PARTS & SERVICE NEWS

REF NO.	AA98174
DATE	November 18, 1998

SUBJECT: AWD BREATHER RETENTION

PURPOSE: To insure that breathers are properly positioned.

Figure 1

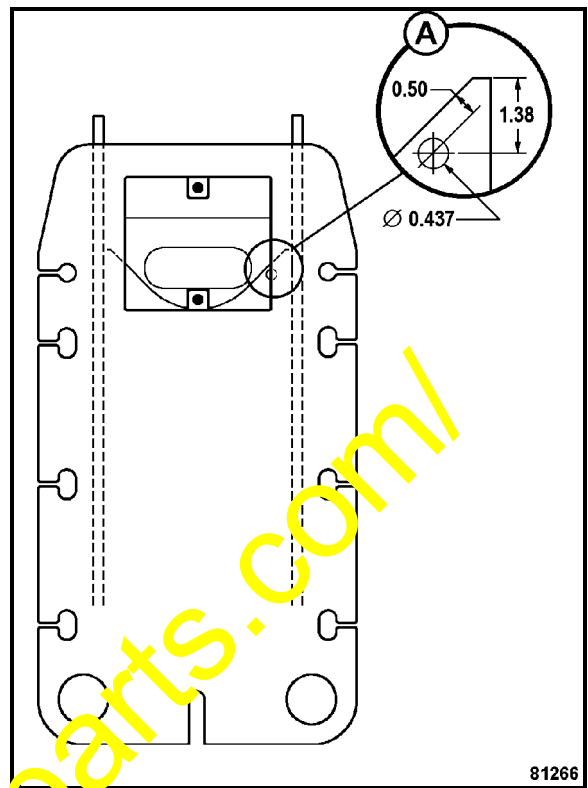
Drill a .375" to .437" hole in the tie plate as indicated at "A" of Figure 1.

Figure 2

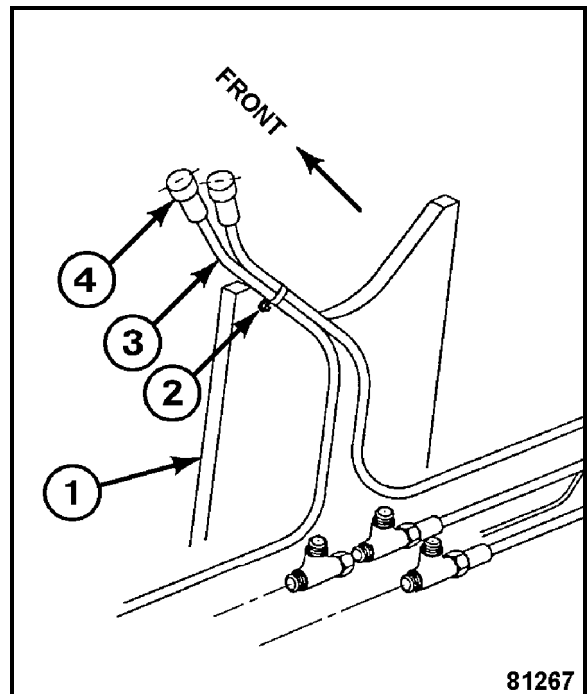
On the back side of tie plate (1, Figure 2) install 130096 clamp (2) around vent hoses (3) with 140483H bolt, 25534R1 flat washer, and 25522R1 hex nut.

Insure that the breather vents (4) are vertical as illustrated and cannot fall.
